## Parts Technical Information

Volume J8  
Number J1  
DATE March 1989

ITEM 1

SUBJECT Oil Filter Element

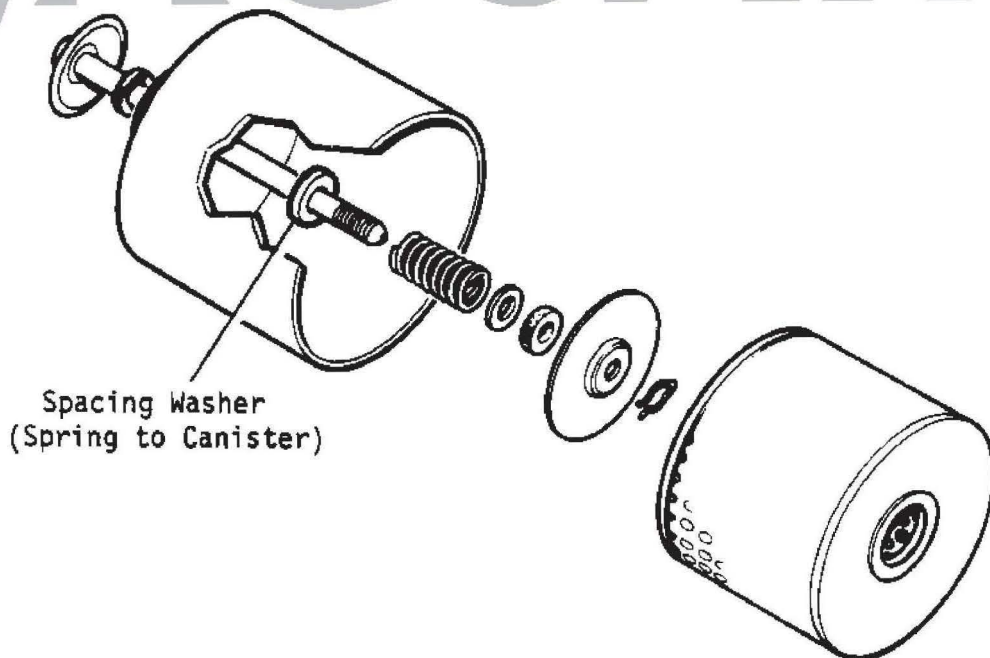
REASON FOR CHANGE The replacement oil filter element, JLM9546 has been found to be 1/8" under dimension. To compensate for this shortfall a plain washer, WA600071/J must be fitted between the pressure spring and the oil filter canister. (See illustration below.)
